In the matter of the
FCC Recycling (UK) Limited Inquiry
Environmental Permitting (England and Wales)
Regulations 2016

FCC RECYCLING (UK) LIMITED and 3C WASTE LIMITED
DANESHILL LANDFILL and MAW GREEN LANDFILL

THE ENVIRONMENT AGENCY'S RESPONSE:
TO THE ADDITIONAL DOCUMENTATION
SERVED BY THE APPELLANT

DATE: 20 February 2024

Figure 1: GIS drawing showing area of development

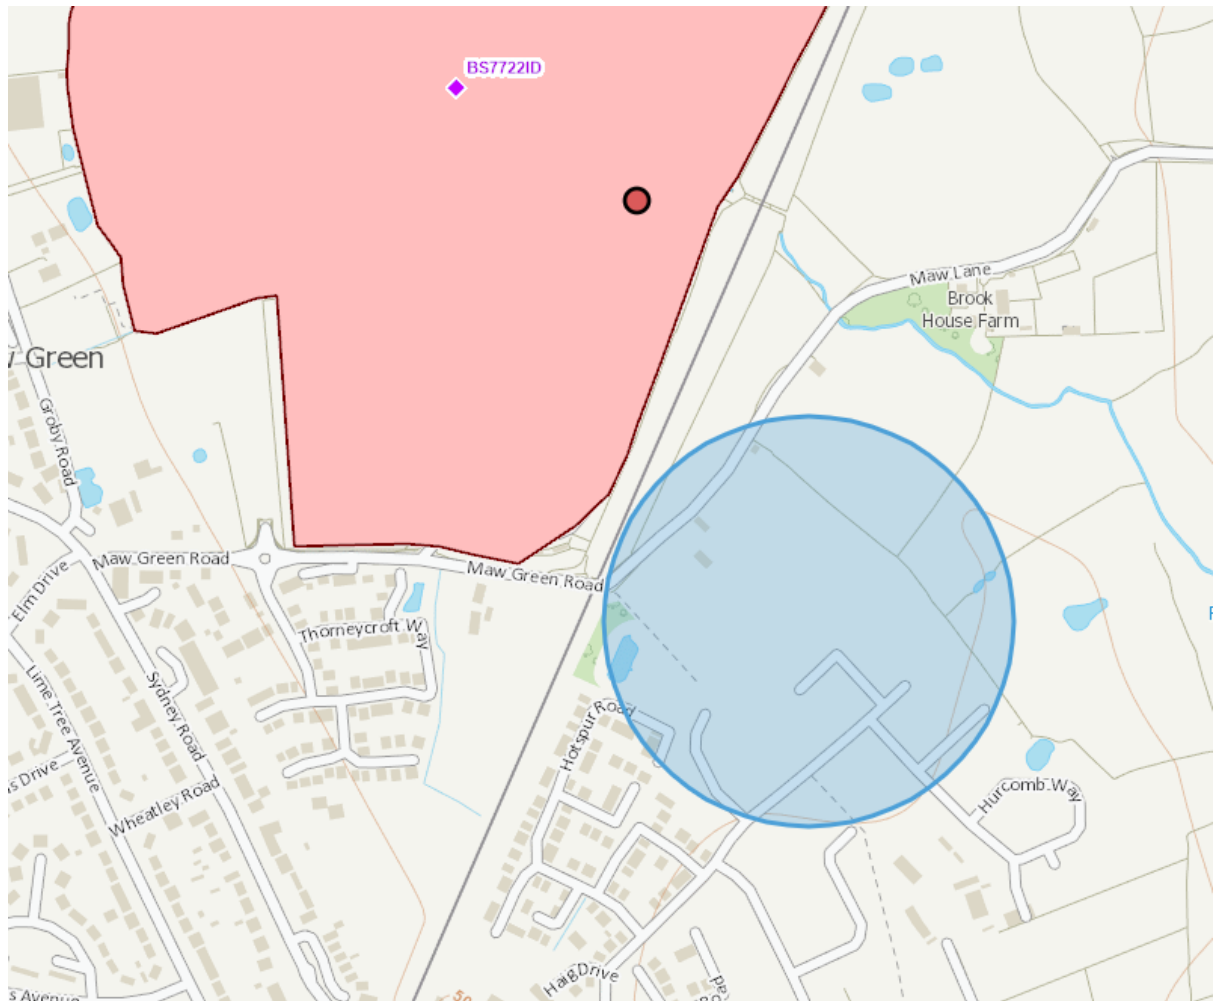
However the Agency notes from our GIS system (Figure 1 below) that there appears to be an area of development extending northeast of Hotspur Road in the area of the blue circle below (the permitted area of the landfill is shown as the pink area and the red point marks the grid reference provided by the Appellant for the STF). An aerial photograph (Figure 2 below) shows housing on Hotspur Road under construction, so it may be this is another area of new housing development. The potential new receptors should be considered (we note these are discussed with regard to the Appellant's proposed emission modelling receptors discussed in Section 7 below). We note also the Appellant uses the same Sensitive Receptors Plan for their Dust and Emissions Management Plan ("DEMP") for the STF.

Figure 3: Maw green proposed receptors

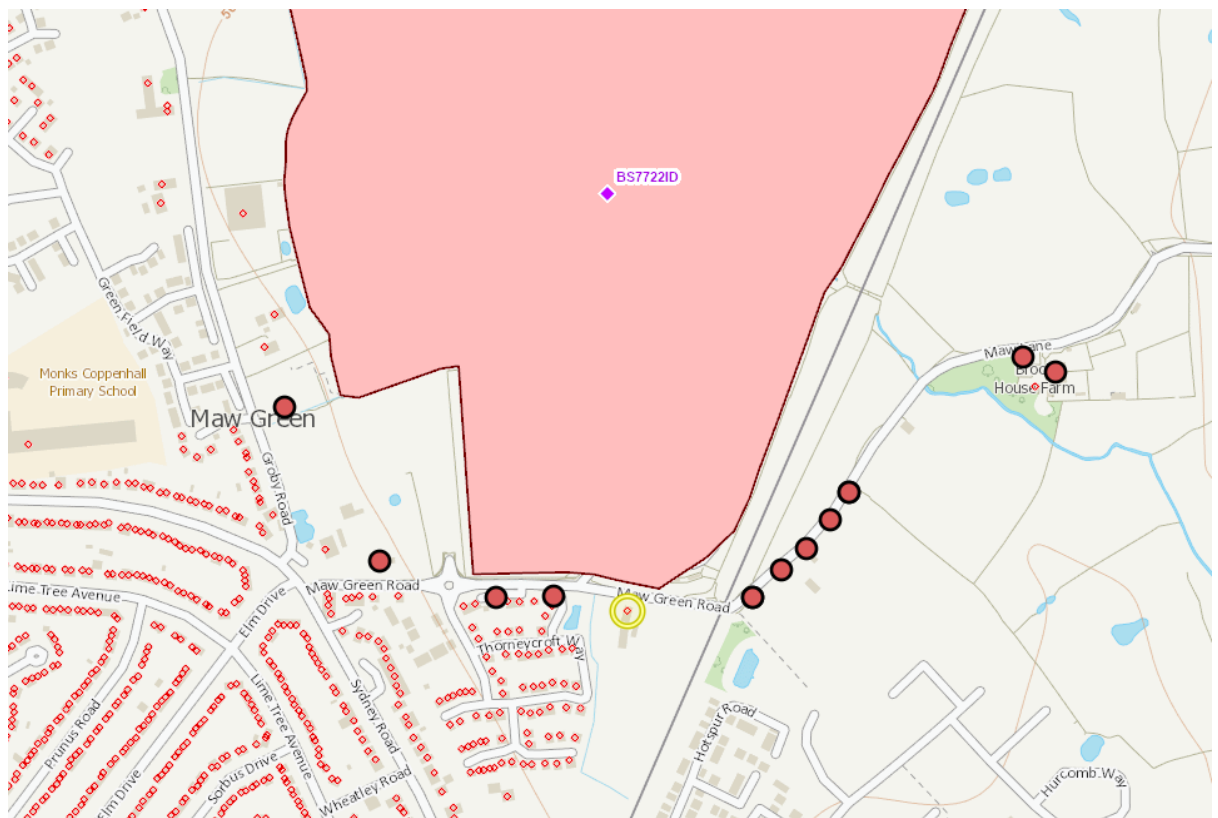
17. The proposed receptors for DH have been discussed in the DH SoC. Section 2 above covers our consideration of the receptors for MG, and the Agency is reassured that the area of new development is included here. We note that there is one potential residential address in a gap on the southern boundary which could be included for better coverage (circled in yellow below):
